Proposed shop-top housing development (DA-482/2017)

59-75 Grafton Street, Bondi Junction

SUPPLEMENTARY STATEMENT OF ENVIRONMENTAL EFFECTS (Revision 1)

Submitted to Waverley Council

Figure 1 – Comparison of original & amended departure from 60m height standard (Source: Cottee Parker JPRA, DA 9005_A and DA 9005_C)

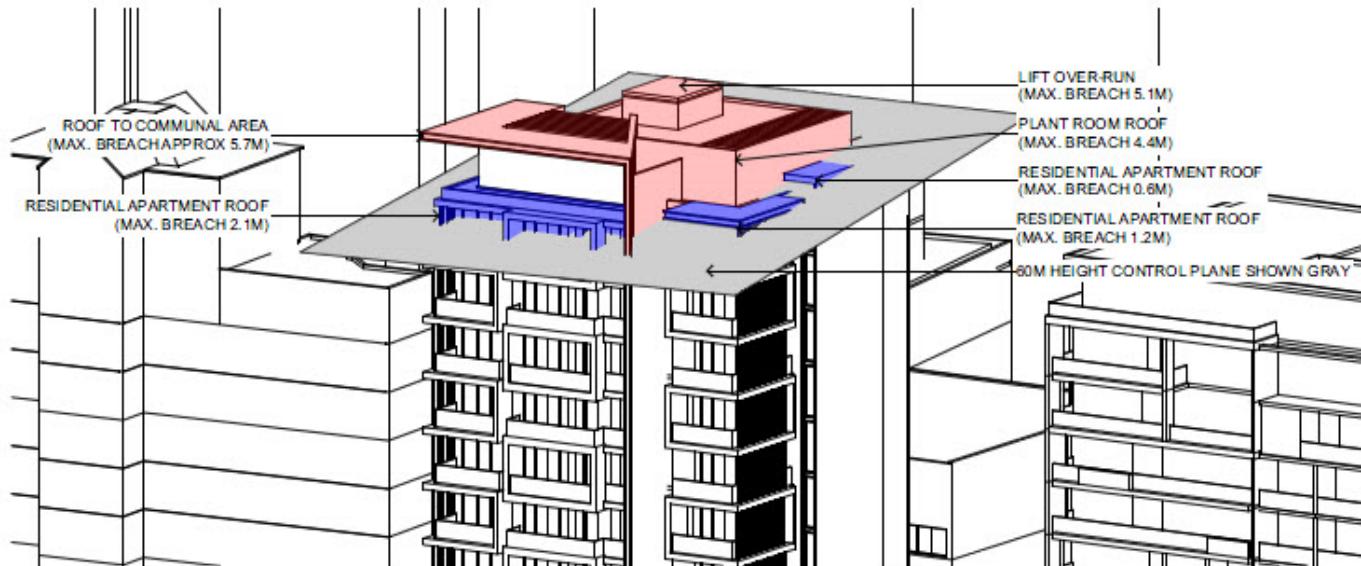
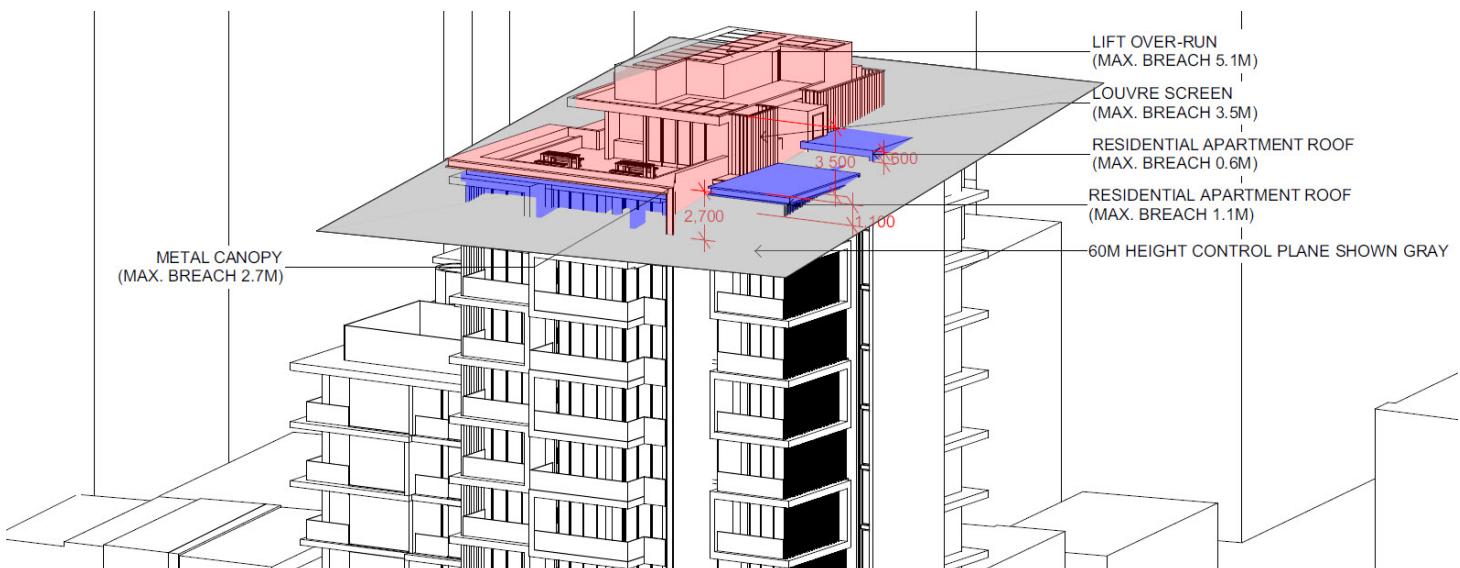
1. The components of the roof which exceed the height development standard, including the roof over the common open space at the front of the site is excessive in bulk and scale, appearing as an additional level. This creates additional shadow impacts on the adjoining residential building to the west which would not be impacted by a compliant form and will interrupt views enjoyed across the site by surrounding buildings.

The site has a 60m height control. This control should not be exceeded by any part of the building including plant, lift overruns or communal space. The extra height over the 60m control being sought by the applicant is not supported by the Panel.

The bulk and scale of the proposed building components at the top of the proposal have been reduced including:

- (a) Deleting the roof terrace hood/pergola over the common open space
- (b) Relocating the A/C and HWU plant
- (c) Deleting the southern roof balustrade (and the pebble roof to the south of the lift core is shown as "NOT TRAFFICABLE" on DA 2112_D, **Appendix B**).

These amendments reduce the overall height from 65.7m to 65.1m. An amended Clause 4.6 Exception to Development Standard - Waverley Local Environmental Plan 2012: Clause 4.3 – Height of buildings accompanies the SSEE (**Appendix D**).

Figures 1 to 3 compare the original and amended DA height non-compliance and built form, illustrating the significant reduction in bulk at the top of the building.

Figure 6 – Amended Lower Ground Floor Plan (Source: Cottee Parker JPRA, DA 2100_D)

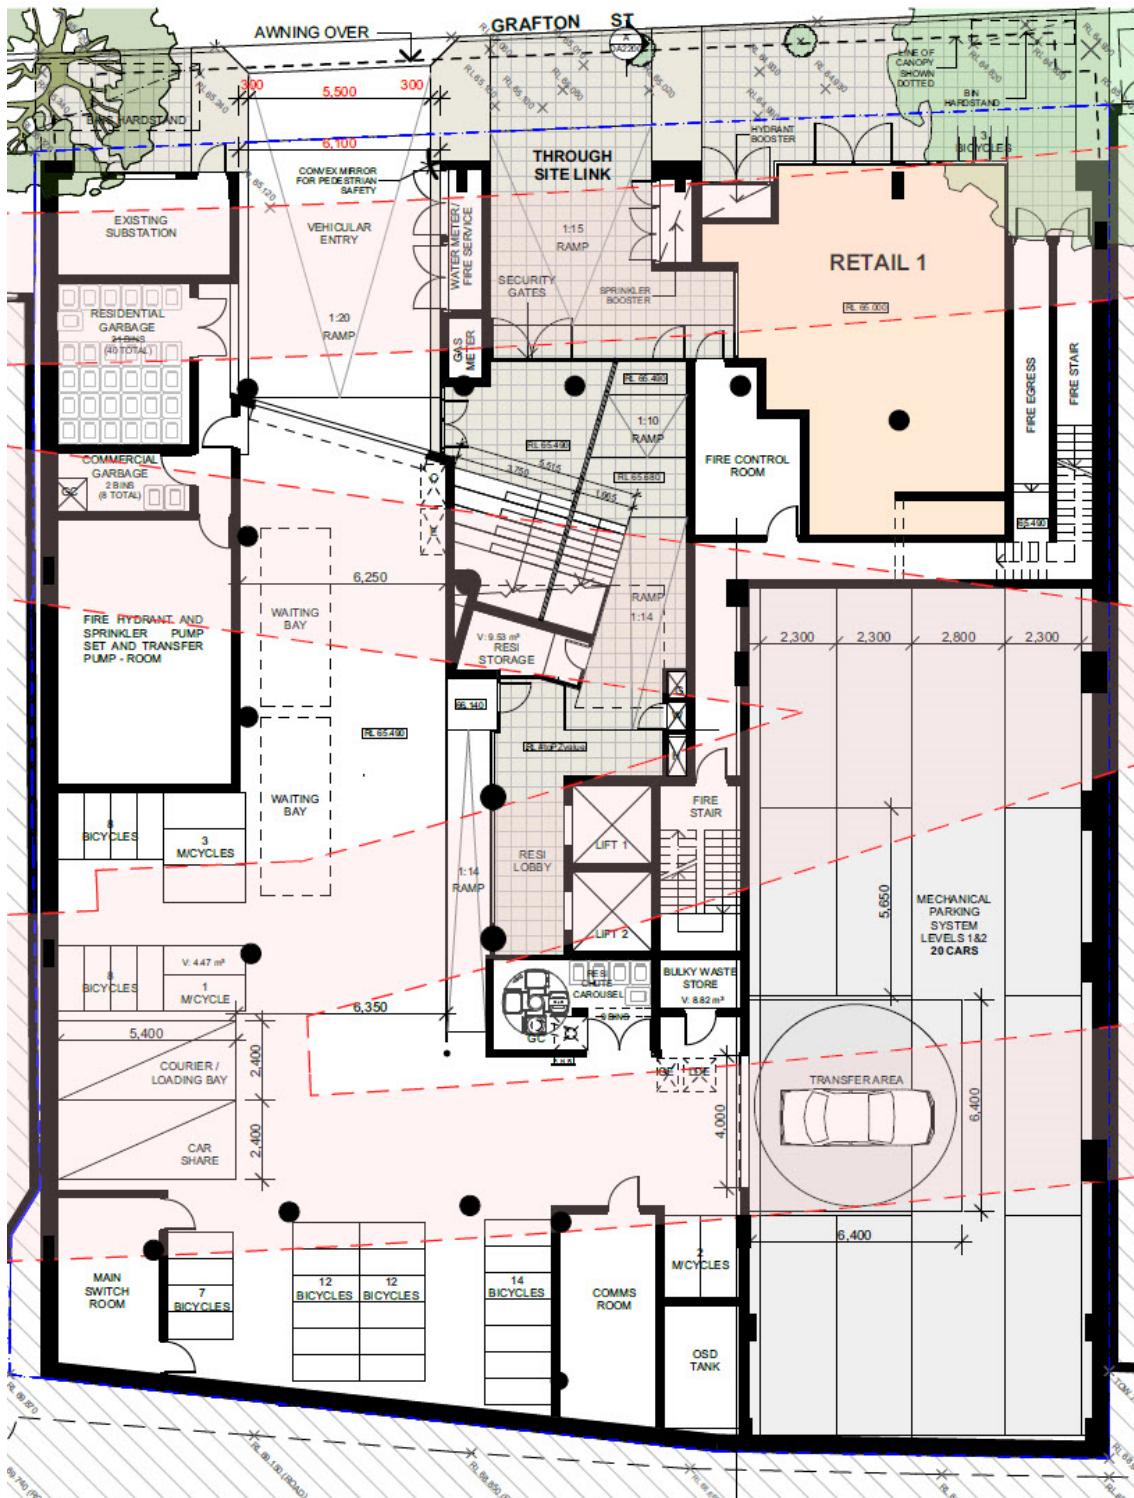
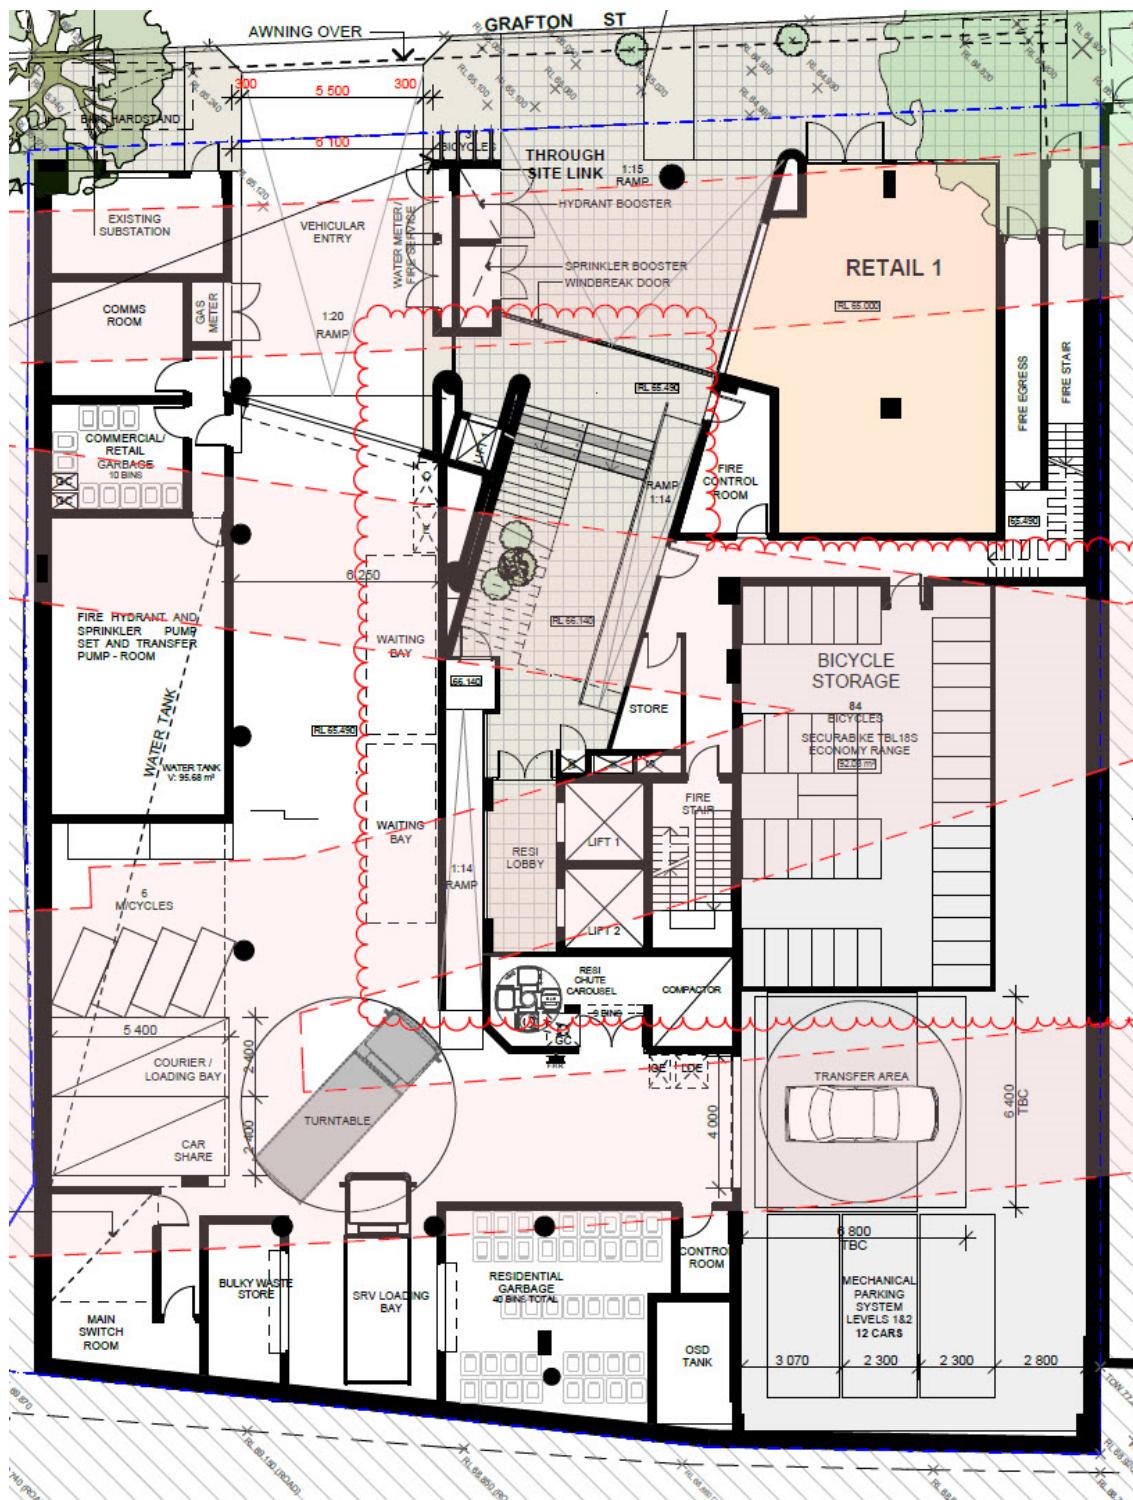
1. The through site link should provide a visual connection from Grafton Street to Hegarty Lane. Given the passage is not in a straight alignment this visual connection is absent. To address this, it is recommended that a double height entry space be provided to the Grafton Street entrance, or the passage be straightened to create that connection. A similar effect should be created at the entrance to Hegarty Lane by adjusting the apartment layout on Level 1 to create a void above the majority of the through site link, maximising the amount of natural light and creating a visual connection between the streets.
2. The pedestrian link should provide equitable access, facilitating wheel chair and pram access.
3. Public art should be incorporated into the through site link to create a visually engaging and attractive through site link.

The through site link needs to be of high quality finishes and design and better activated to improve the neighbourhood connectivity, safety and opportunity for small service businesses along the new through-site link

The activation of Grafton Street and the through-site link need to be improved. The retail in Grafton Street should turn the corner and not be obstructed by services, so that its presence can be noticed from the link. The Panel recommends that the hydrant booster, sprinkler booster, fire control room, public lift, 1:10 ramping, position and detail of the security gates, fire egress recess, bridge, service risers, view into toilets and garbage room area, floor wall and glazing finishes, floor level and setback of Retail 3 (the floor level should relate to Hegarty Lane to assist its activation), bike positions, glass canopy and tree planting all be reviewed in detail to achieve a high quality pedestrian and retail experience. Detailed sections through the link showing line-of-sight and looking east and west would be recommended for review. Good CPTED design, natural daylight and solar access is a clear expectation in the ADG for common circulation areas.

- (a) Removing the central commercial space at the Grafton Street Upper Ground Floor (previously Commercial 2), connecting bridge and street awning to create a double volume entry space at Grafton Street
- (b) Reconfiguring the Hegarty Lane entry and retail spaces
- (c) Providing a large inset in the south-west corner of the site to increase the building setback from the western boundary and Hegarty Lane, to create an appealing publicly accessible space and increase solar access to the through site link and apartments above facing Hegarty Lane.

Figures 5 to 8 compare the original and proposed Lower and Upper Ground Floor plans showing how the through site link arrangements have been amended to address Council and WDEP issues (DA 2100_D and 2101_D, **Appendix B**).

An amended Landscape Plan has also been prepared showing a new feature tree in the public space in the south-west corner of the site. The soil around the tree is to have a depth of 1m recessed into to the slab above the main switch room (see DA 2100_D, **Appendix B**) which obviates the need for raised planter walls.

The Lower Ground Floor fire hydrant booster cupboards have been moved to the western side of the through site link at Grafton Street, with an additional shopfront created to Retail 1 facing and activating the through site link (see DA2100_D, DA2101_D, DA2200_D, **Appendix B**).

A lift is now proposed beside the new double entry space to provide equitable access between Grafton Street and Hegarty Lane (DA 2100_D and DA 2101_D, **Appendix B**).

Figure 8 – Amended Upper Ground Floor Plan (Source: Cottee Parker JPRA, DA 2101_D)

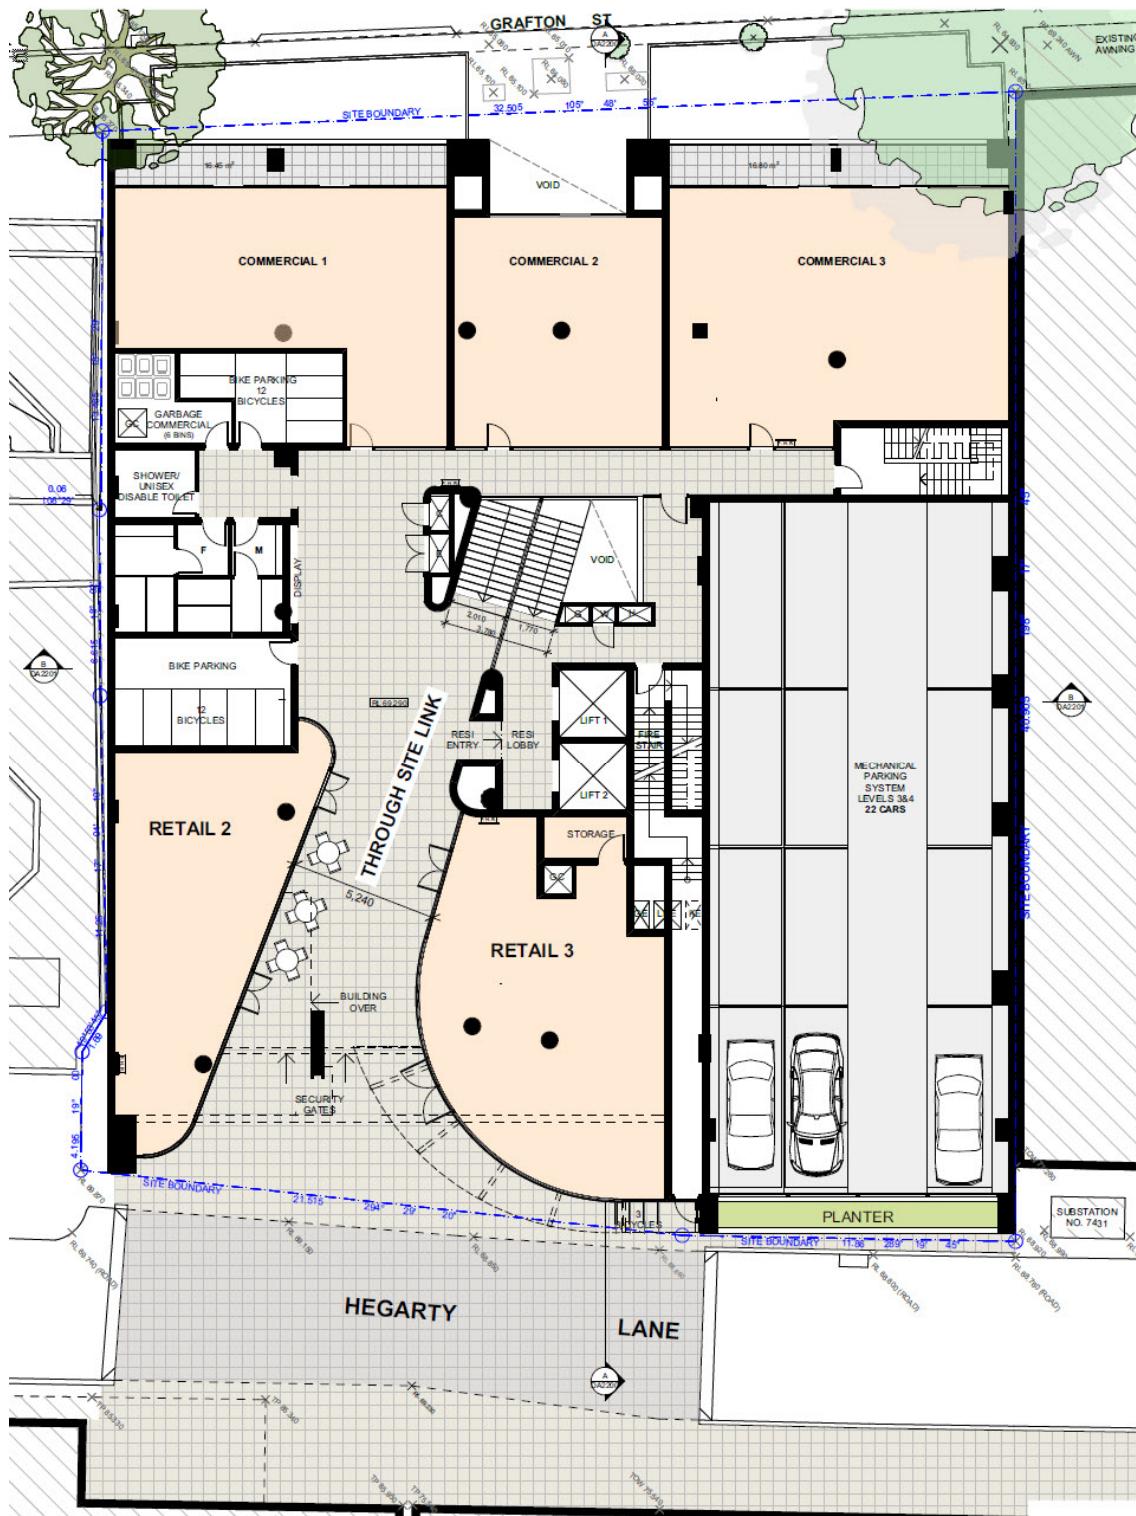
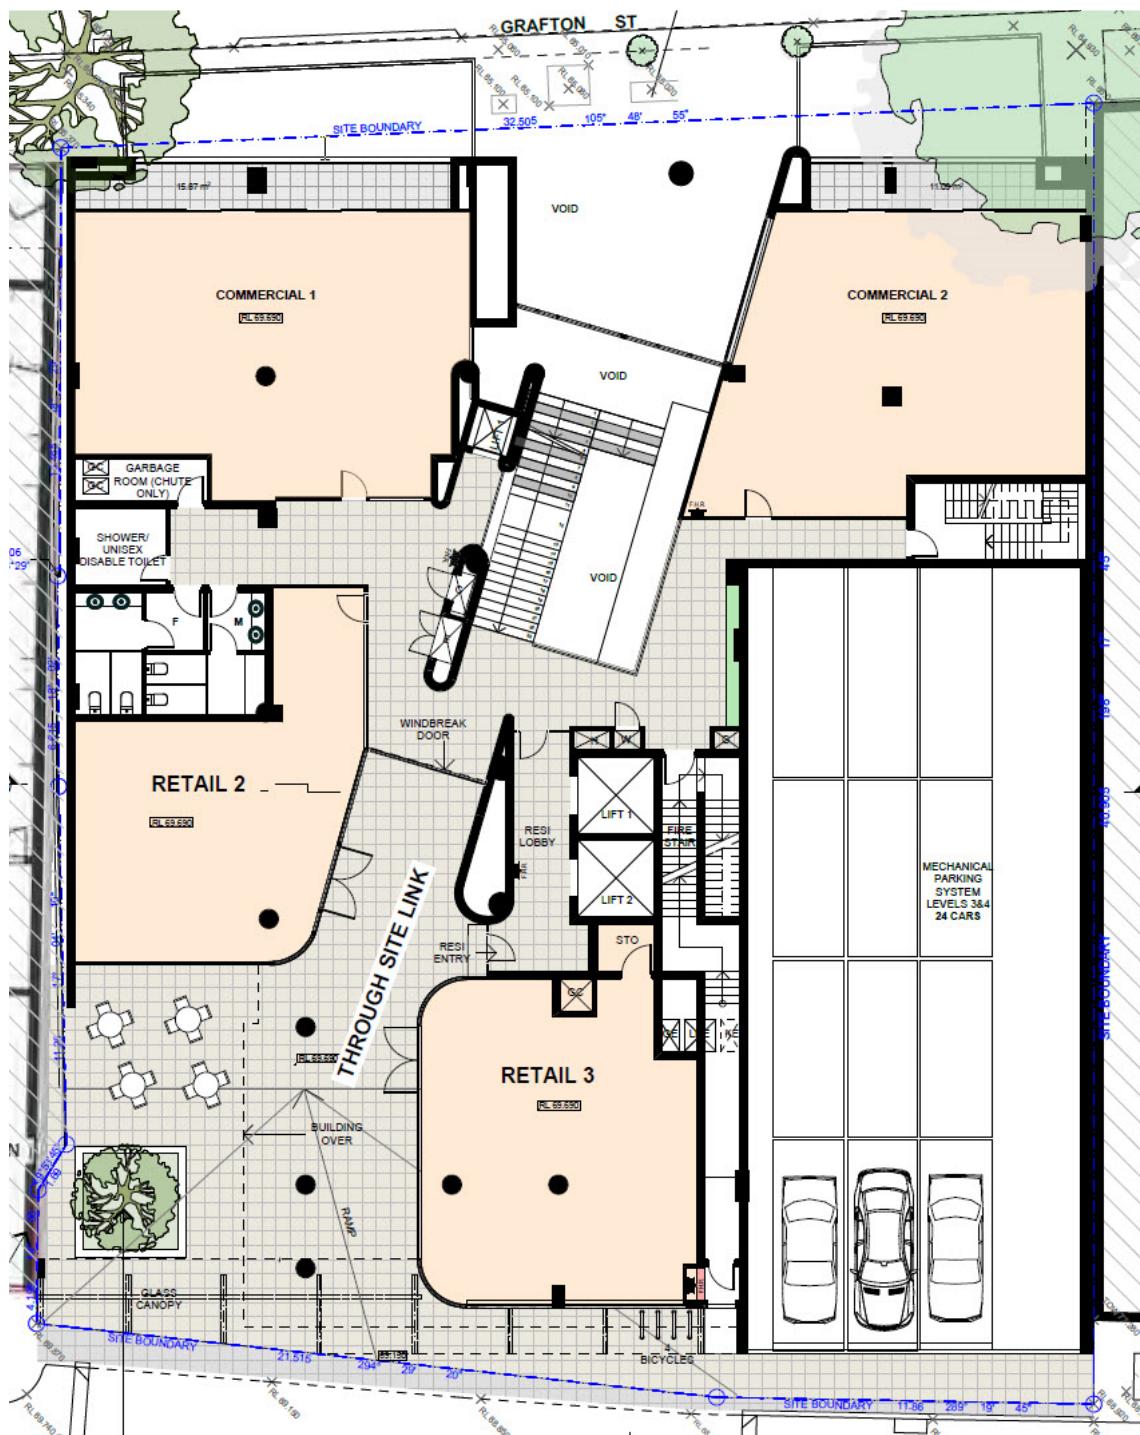
1. The building is not built to the property boundaries to Grafton Street or Hegarty Lane resulting in awkward indents that are at odds with CPTED principles and create ambiguity regarding the ownership of the space, as it appears to be the public domain (maintained by Council) but are indeed with the ownership of the property. The location of the security gate on the lower ground floor to Hegarty Lane is also of concern in this regard.

- (a) The amended proposal is contained within the site boundaries
- (b) The amended Upper Ground Floor arrangement and recess above (see **Figure 8** above) resolves the irregular western side boundary adjoining 45-57 Grafton Street, ensuring that there are no awkward unbuilt upon recesses (a boundary adjustment to regularise the boundary is being negotiated with the owner of 45-57 Grafton Street).

The building has been setback to provide a footpath along the site frontage to Hegarty Lane. Reducing the depth of the frame around the mechanical parking system and lowering the glazing will ensure that there is a sightline from the public domain into the kinetic artwork adding to the streetscape character of Hegarty Lane (see amended Upper Ground Floor Plan at **Figure 8**).

- (a) The communal open space at Level 1 in the Original DA has been deleted to provide for a new publicly accessible open space adjoining the pedestrian through site link at Hegarty Lane on the Upper Ground Floor (see amended Upper Ground Floor Plan at **Figure 8**).
